**Addendum No. 2**  
**November 17, 2021**

Project: Corsica-Stickney H.S. Addition  
Corsica, South Dakota  
Architect's Project No.: 2910

Architect: Architecture Incorporated

2.20

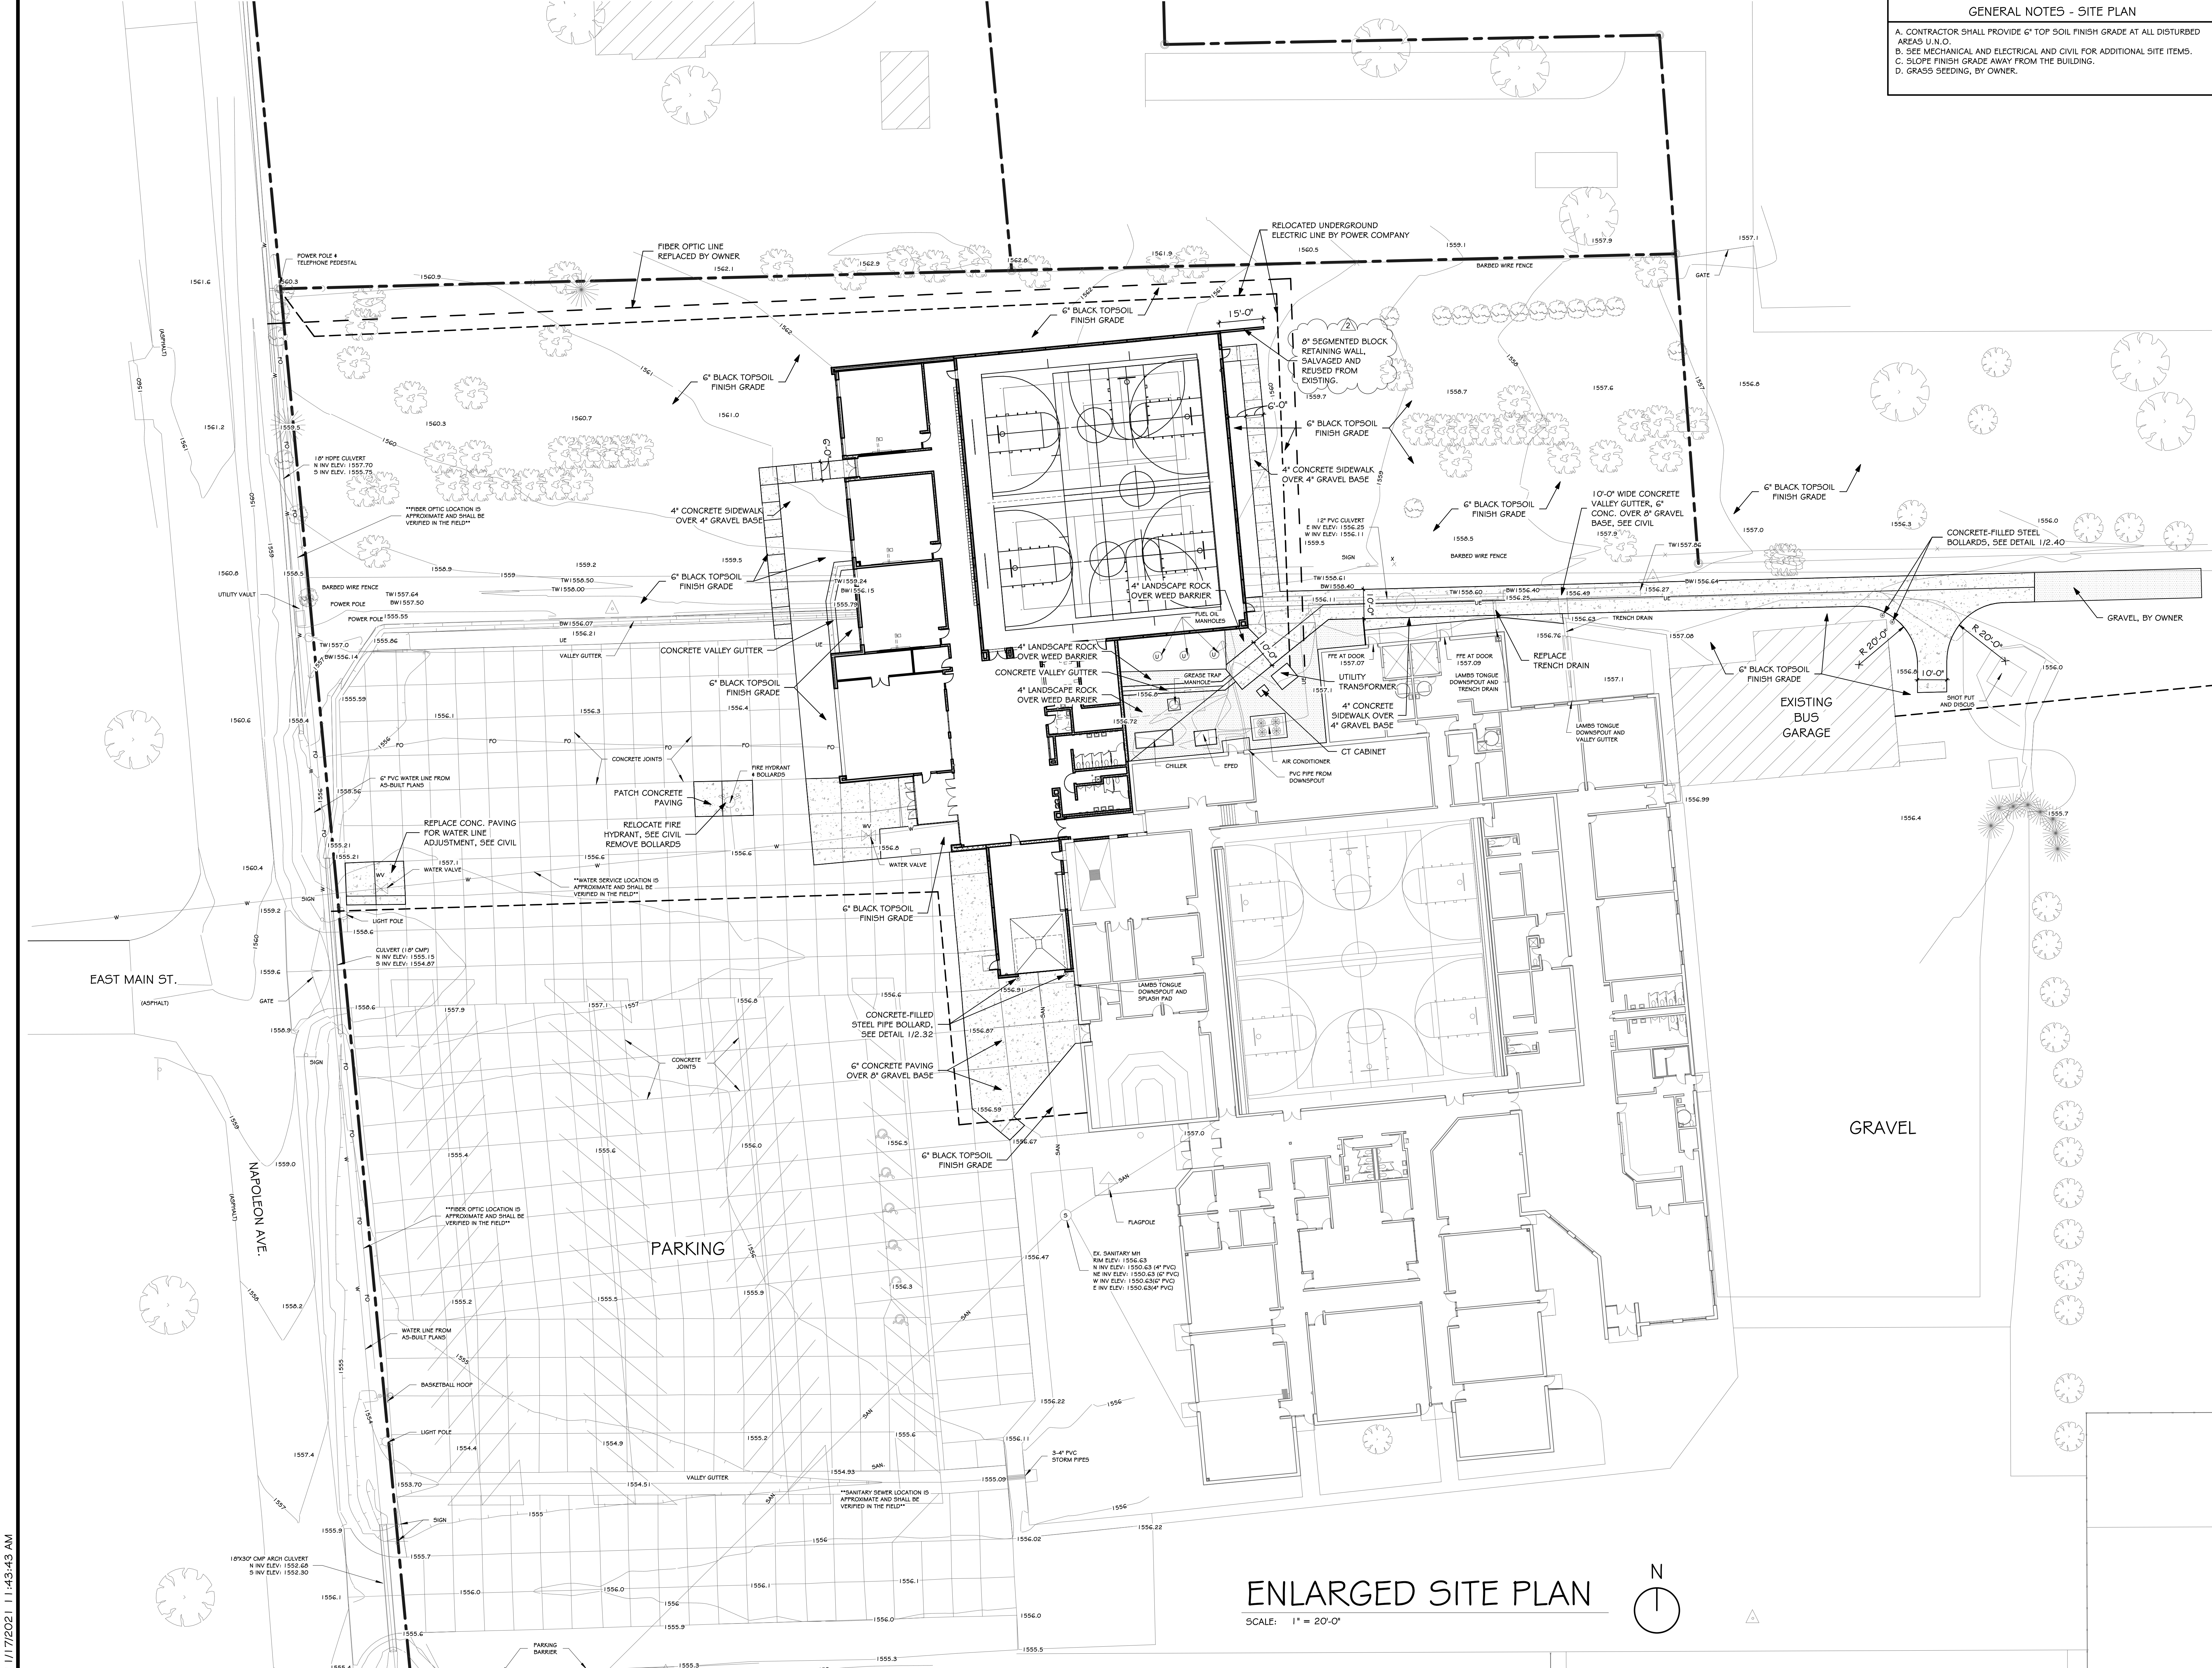
- 6) SHEET 2.20 ENLARGED SITE DEMOLITION PLAN: See new sheet clouded and tagged with "2"

- a) **MODIFY:** Note to Salvage and reuse a portion of existing retaining wall.
- 7) **SHEET 2.31 ENLARGED SITE PLAN:** See new sheet clouded and tagged with “2”
